Field Report

North Hampton Public Library

Project No: 13-020-00

Field Report No: 002

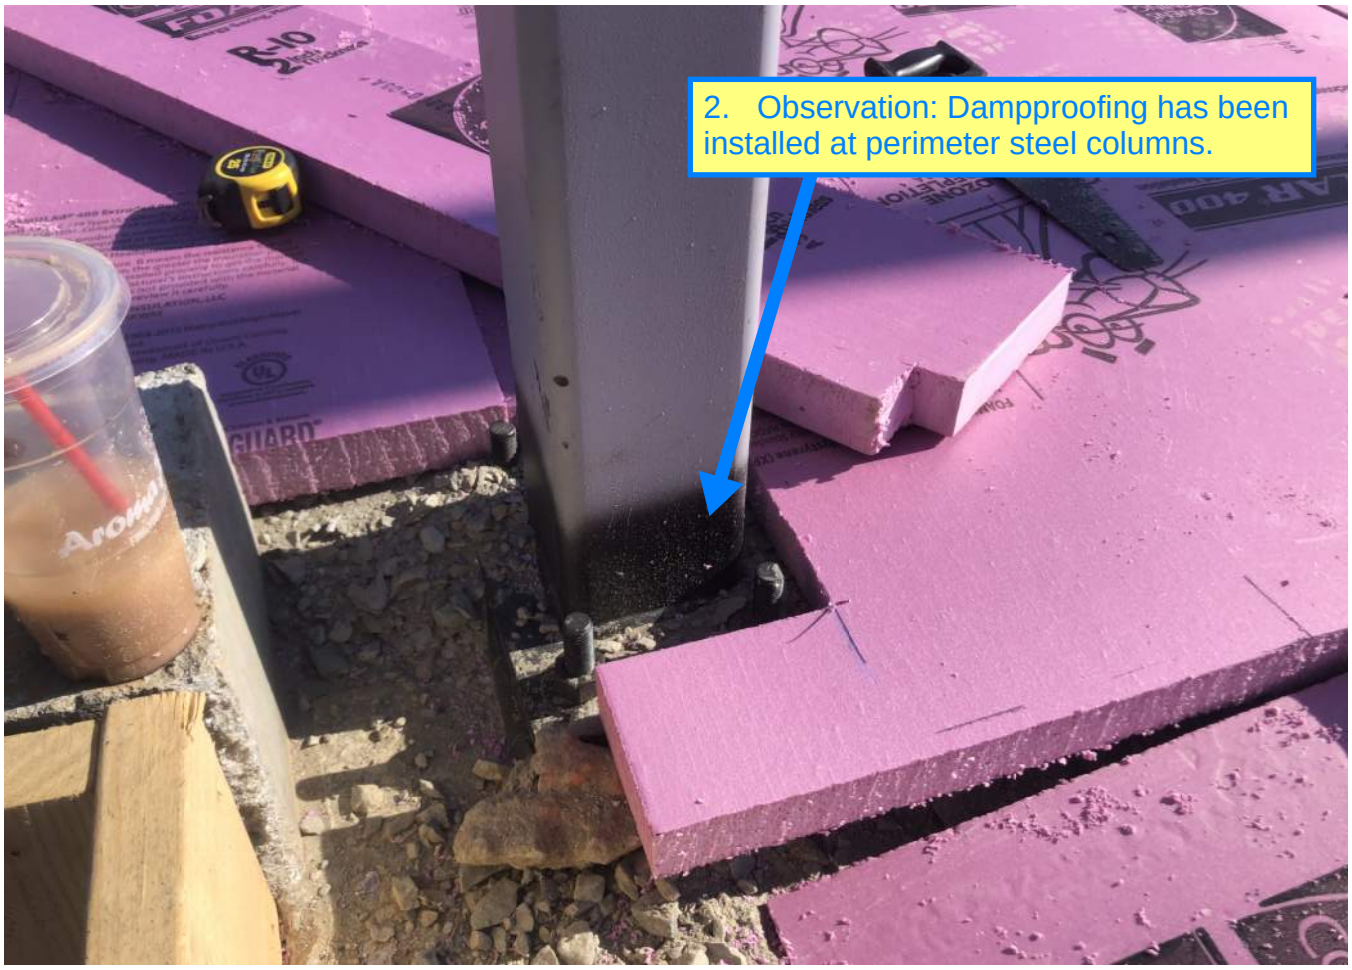
1. Observation: Specified underslab insulation has been installed.
OWENS CORNING
FOAMULAR 400
Energy-Saving, Moisture-Resistant High Density XPS Insulation
R-10
2 Inch Thickness
ZERO OZONE DEPLETION FORMULA
GREENGUARD

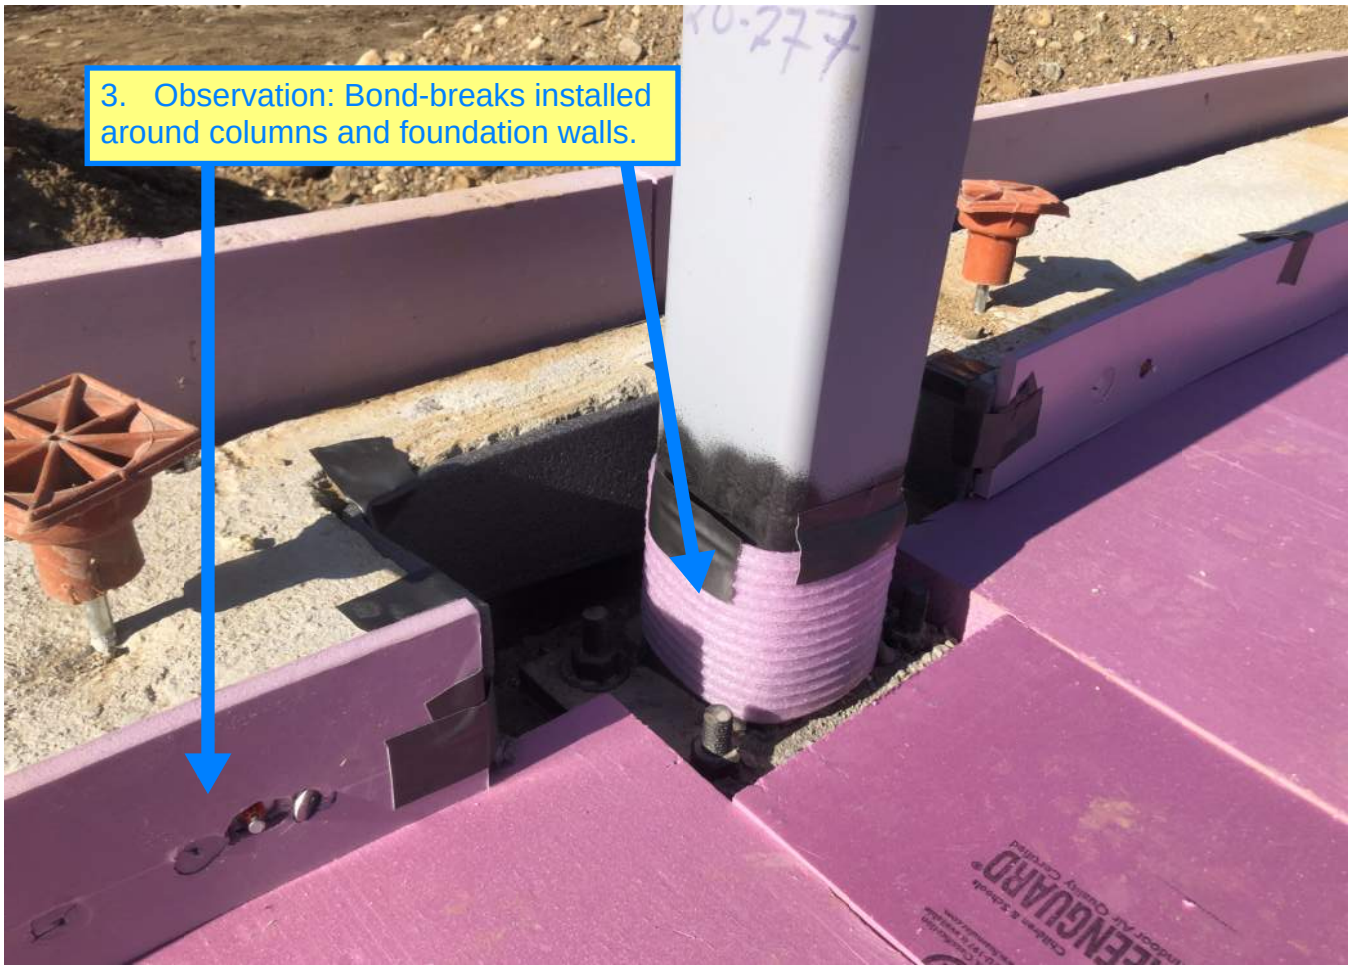
2. Observation: Dampproofing has been installed at perimeter steel columns.

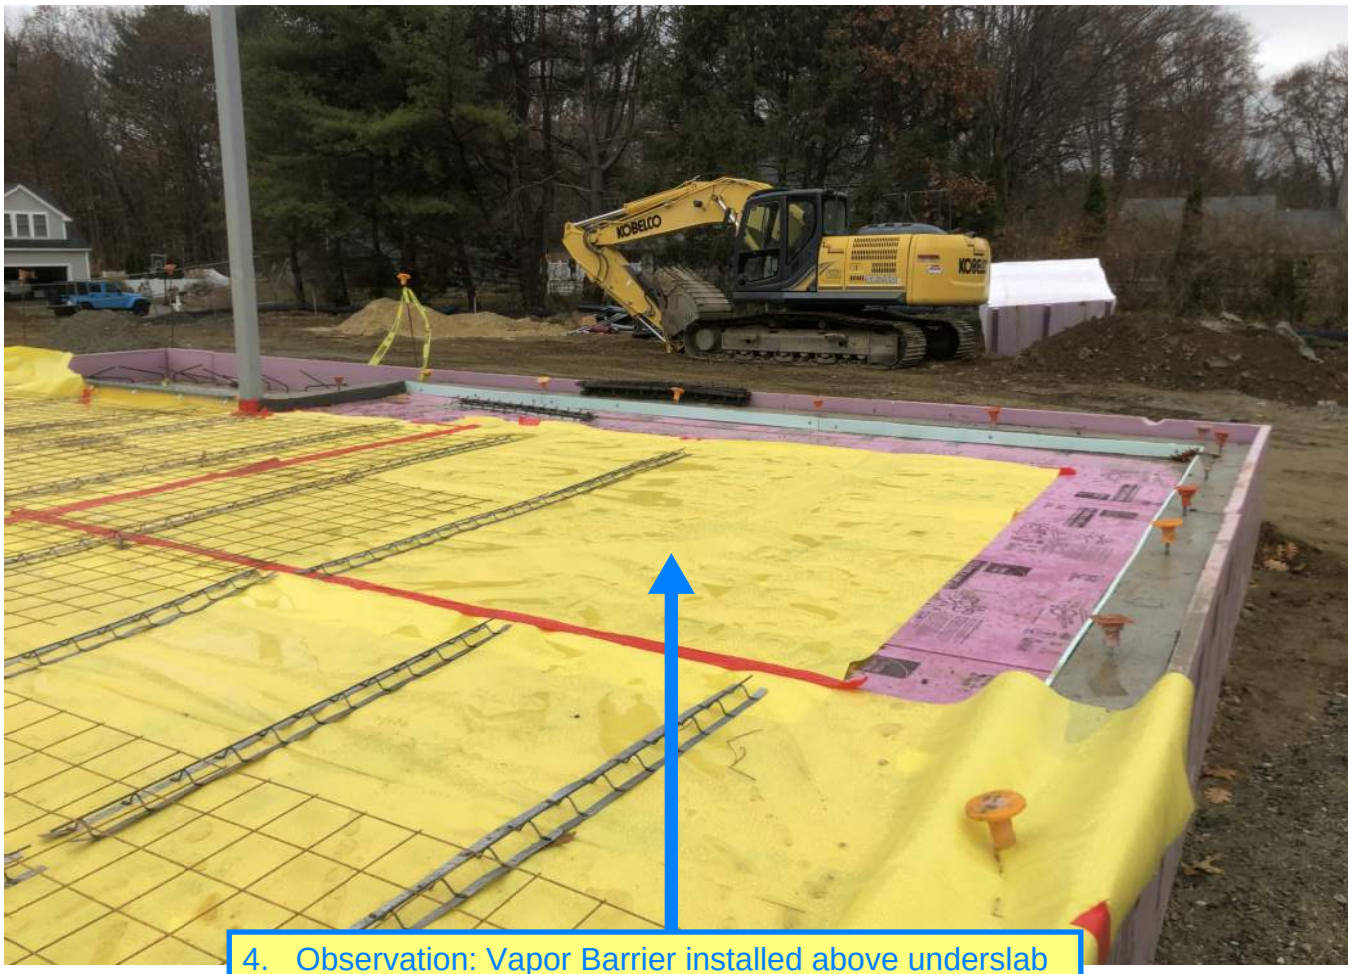
3. Observation: Bond-breaks installed around columns and foundation walls.

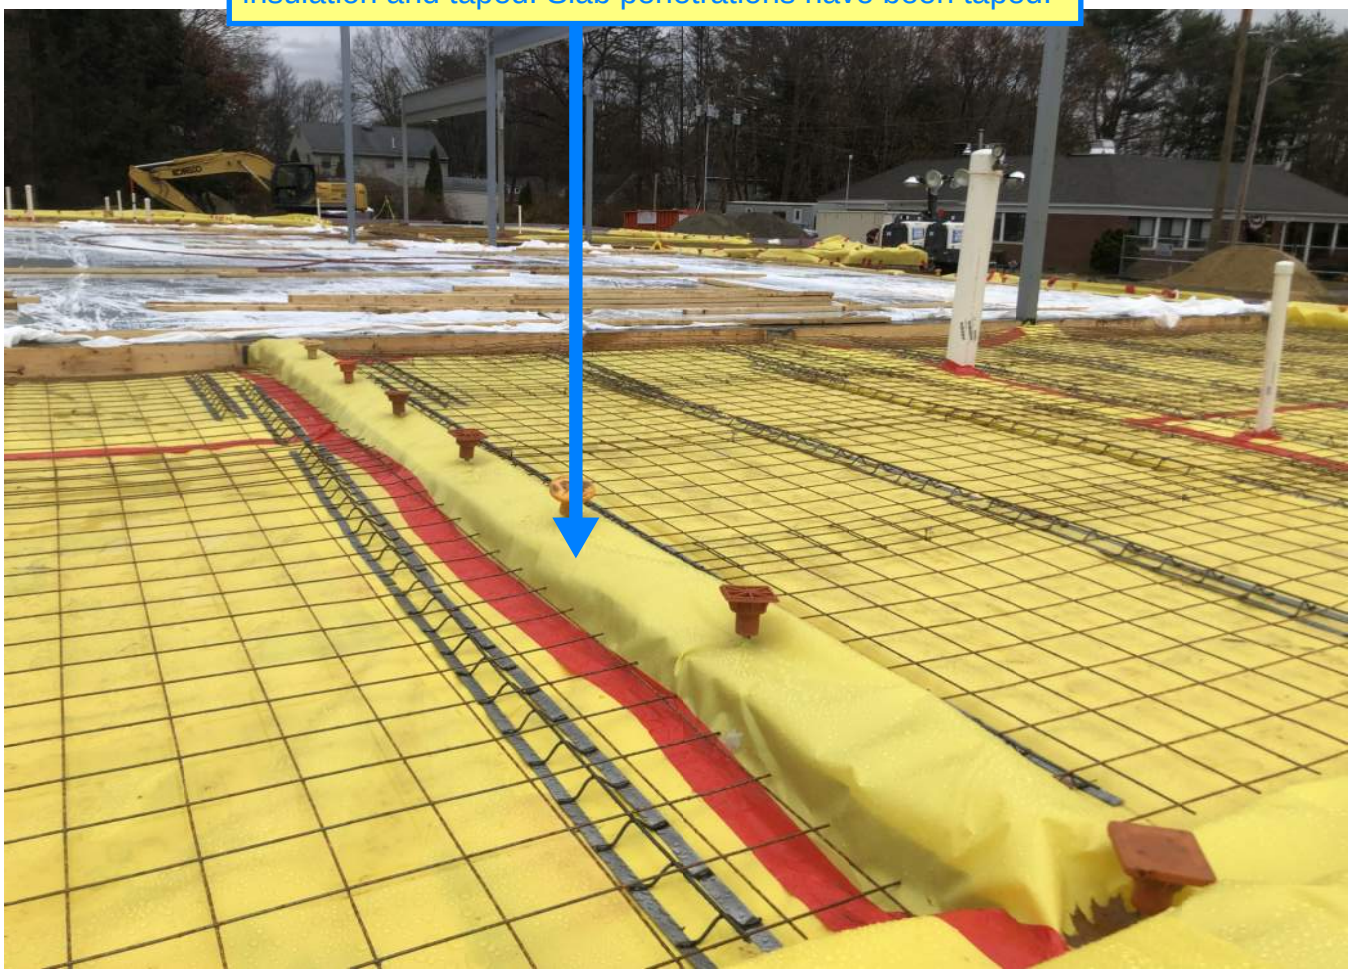
4. Observation: Vapor Barrier installed above underslab insulation and taped. Slab penetrations have been taped.

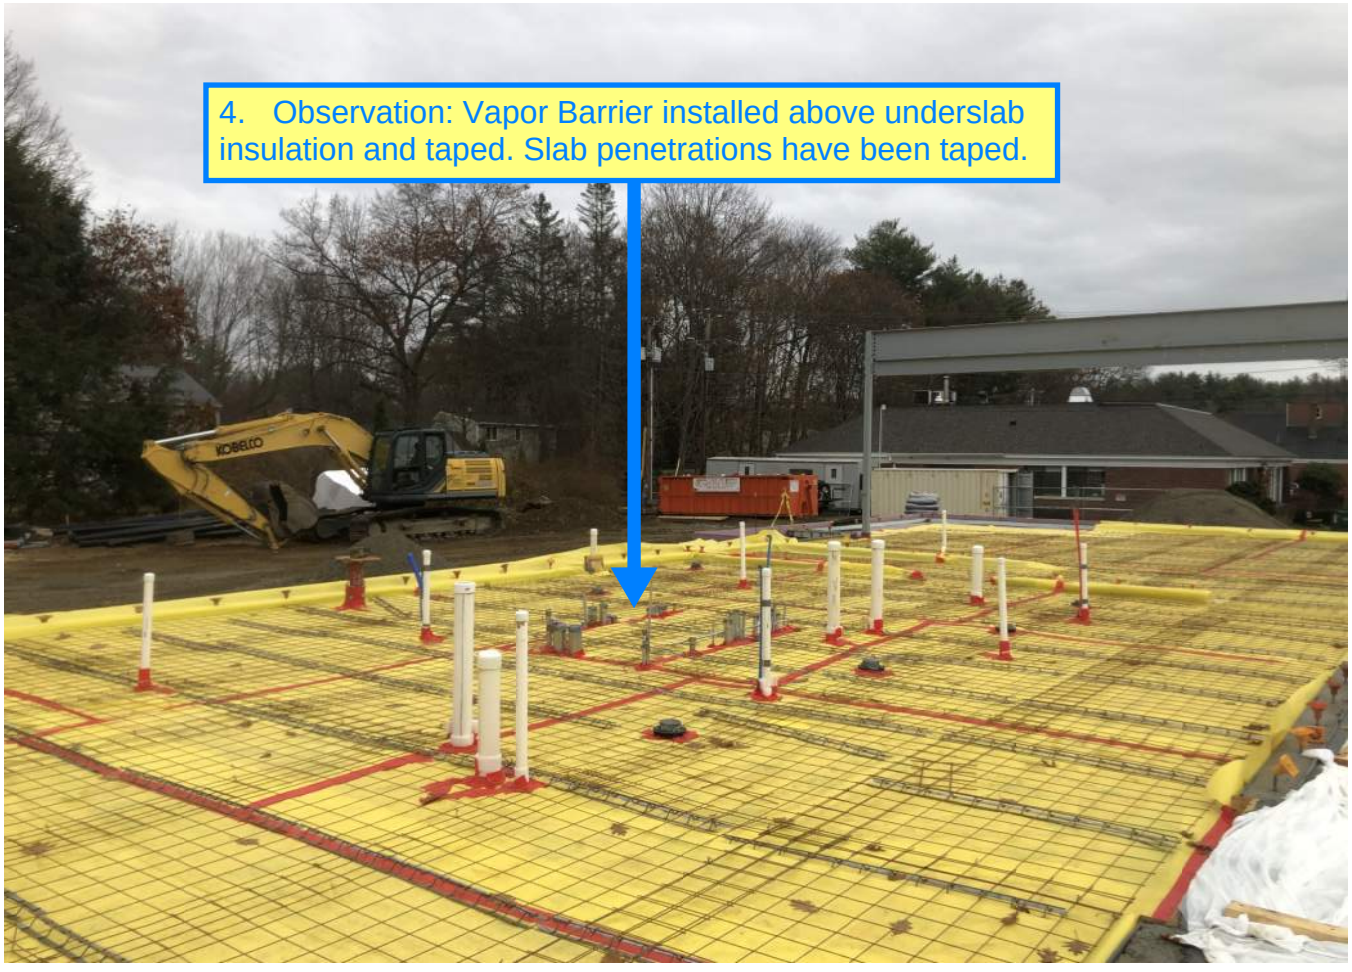
5. Observation: Double-angle sills placed at doorway locations.

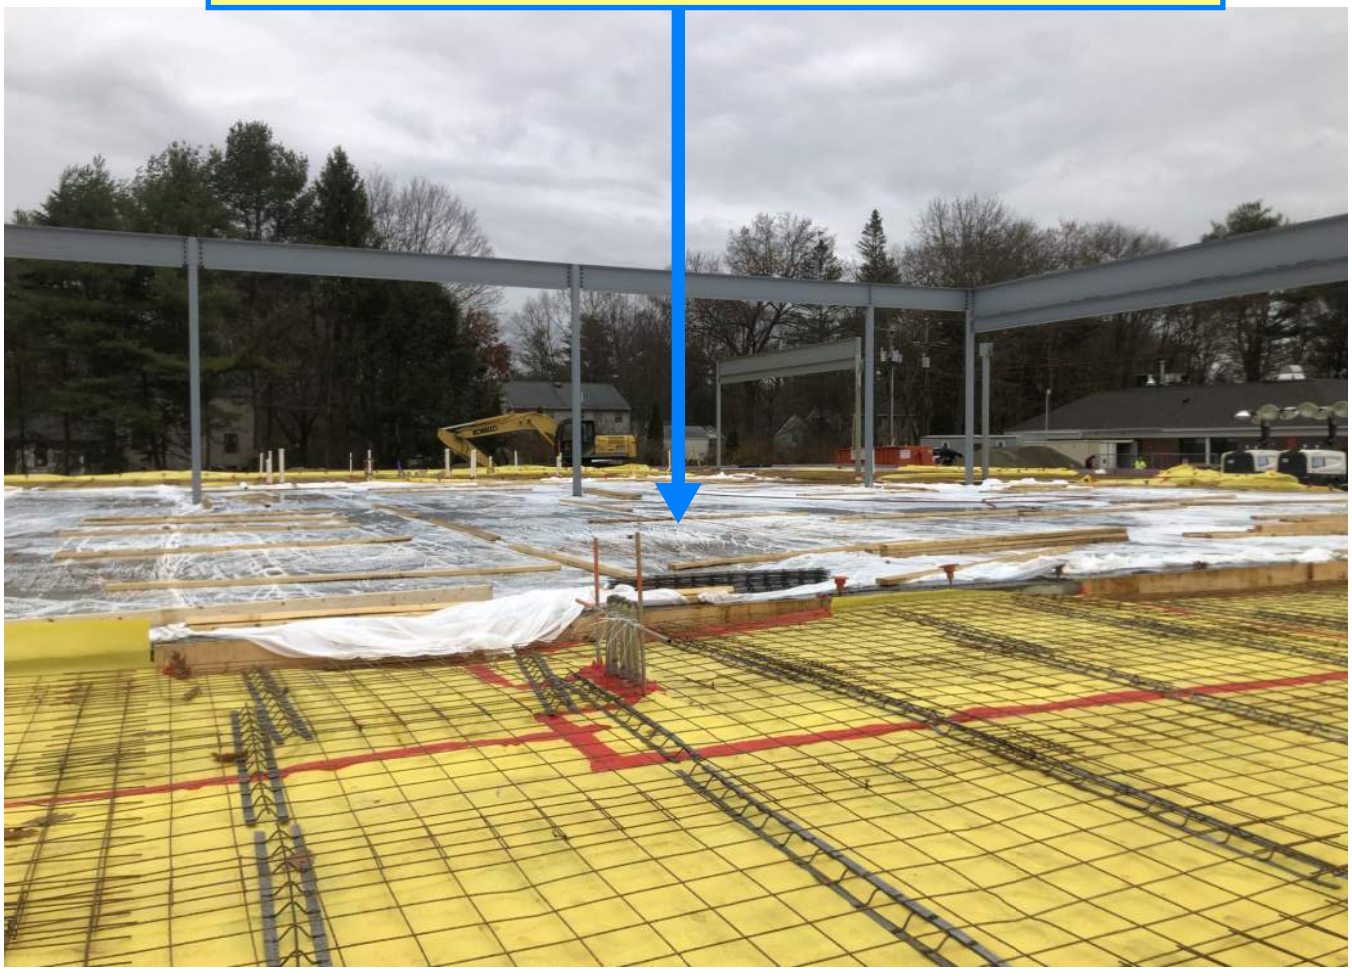
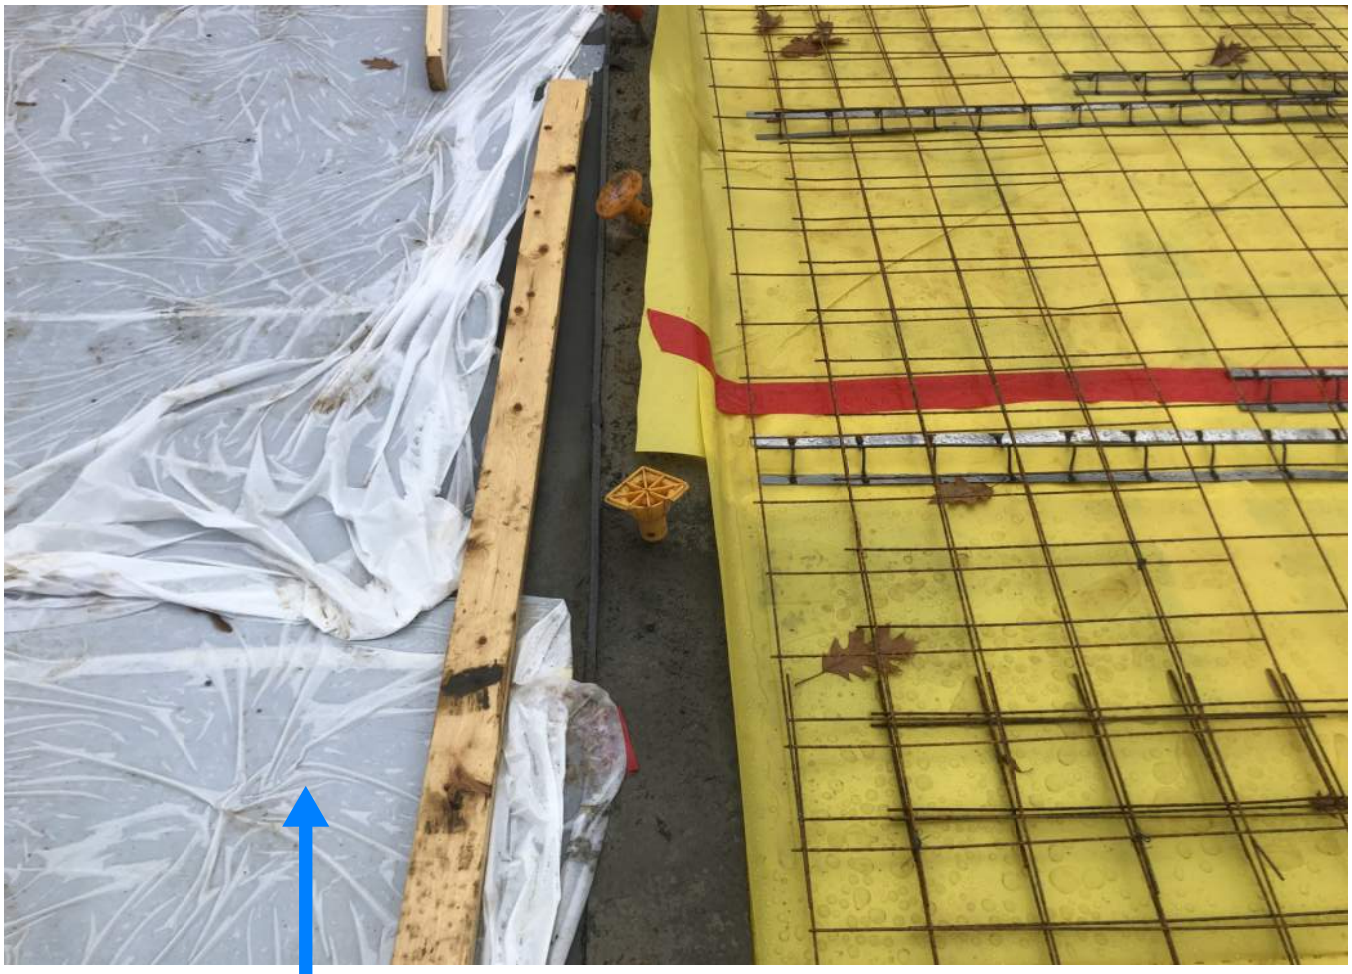
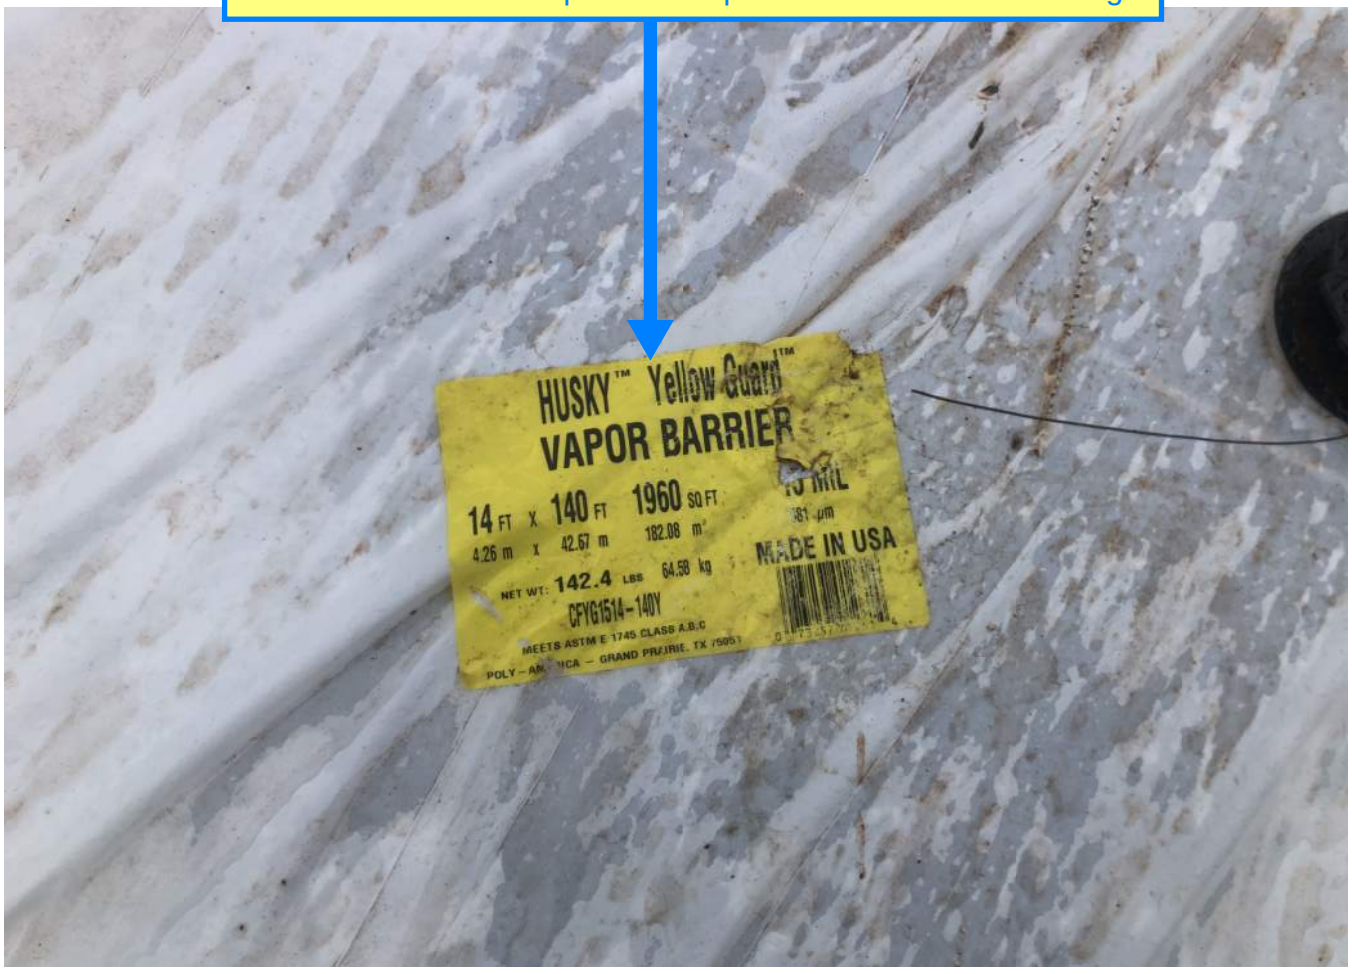
7. Observation: 5" slab placed first, then 4" slabs. Control joints have been saw-cut. Vapor Barrier placed above slab for curing.
